## **MEMORANDUM**

**REVIEW TYPE:** Preliminary Plan Review

**PROJECT NAME:** Petruccelli's Corner

**CASE #:** 120061000

PRELIMINARY PLAN  
**PETRUCCELLI'S CORNER**  
 Montgomery County, Maryland

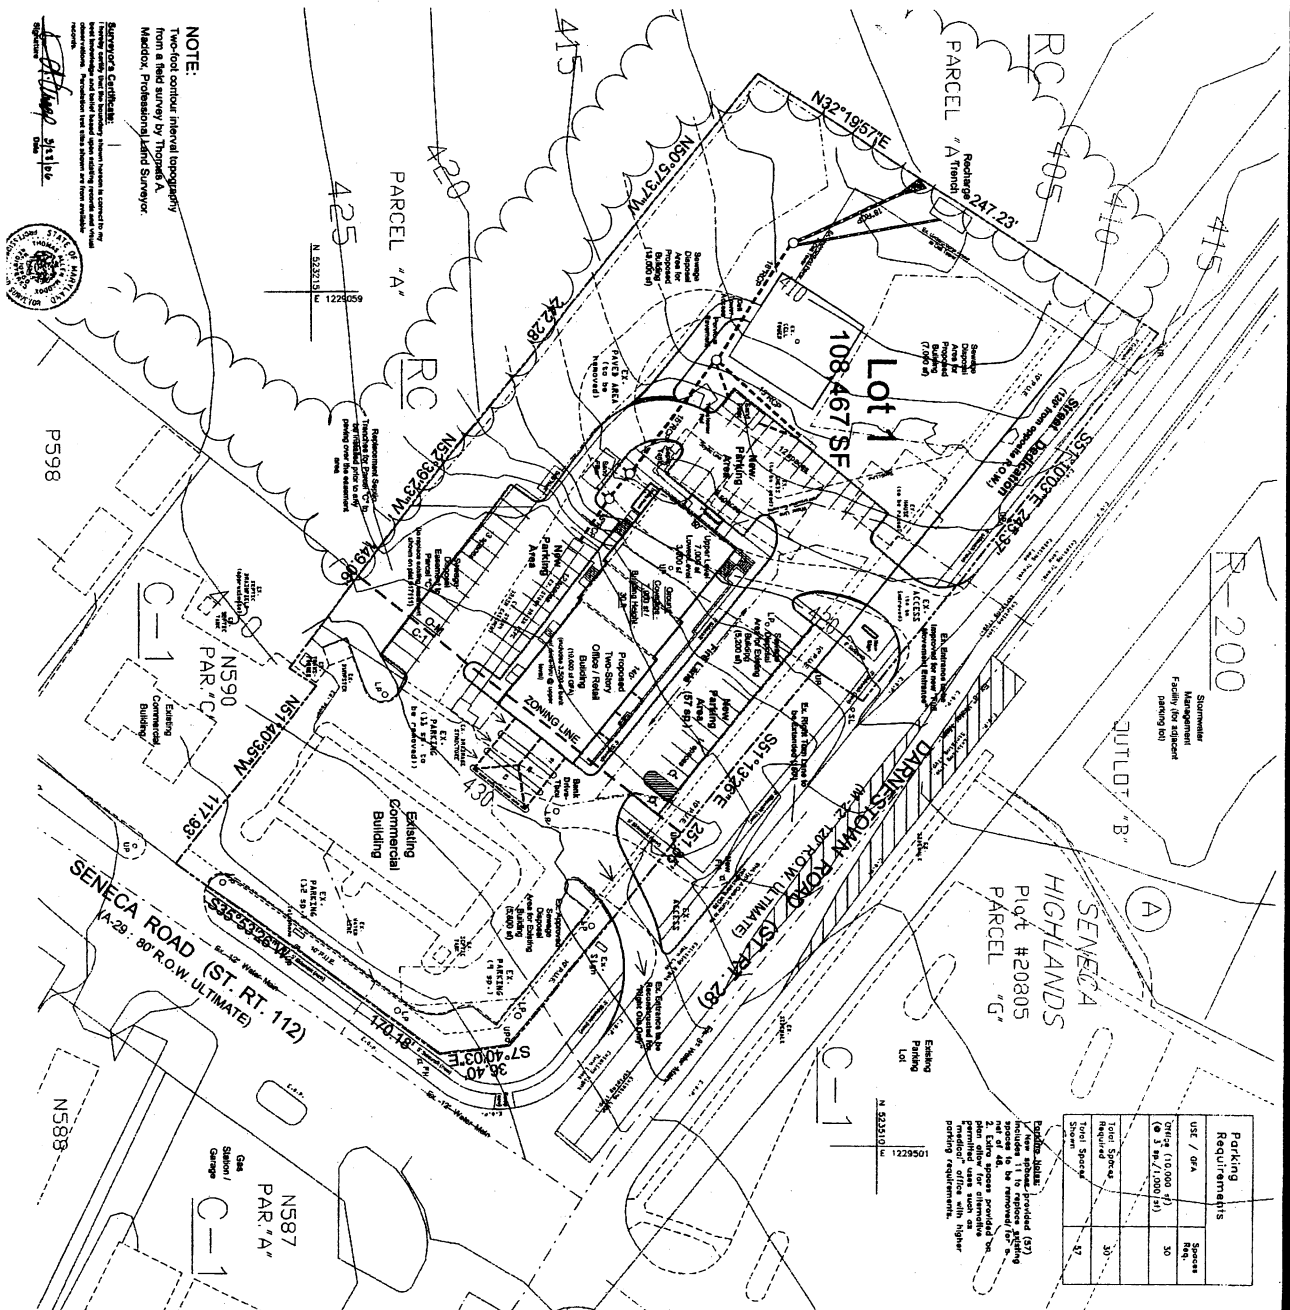
- 13) Before certification of the preliminary plan, the plan must be modified to note the correct building area of the existing commercial building and the correct floor area ratio of the total proposed and retained development on the site.

We have completed our review of the preliminary plan dated 3/28/06. This plan was reviewed by the Development Review Committee at its meeting on 4/24/06. We recommend approval of the plan subject to the following comments:

1. Show/label all existing planimetric and topographic details specifically storm drainage as well as existing rights of way and easements on the preliminary plan.
2. Necessary dedication for Darnestown Road and Seneca Road in accordance with the master plan.
3. Grant necessary slope and drainage easements. Slope easements are to be determined by study or set at the building restriction line.
4. Septic systems cannot be located within the right of way nor slope or drainage easements.
5. In accordance with Section 49-35(e) of the Montgomery County Code, sidewalks are required to serve the proposed subdivision. Sidewalks are to be provided along the site frontage.
6. Revise the plan as necessary to meet the requirements of the Montgomery County Department of Permitting Services with regard to septic systems.
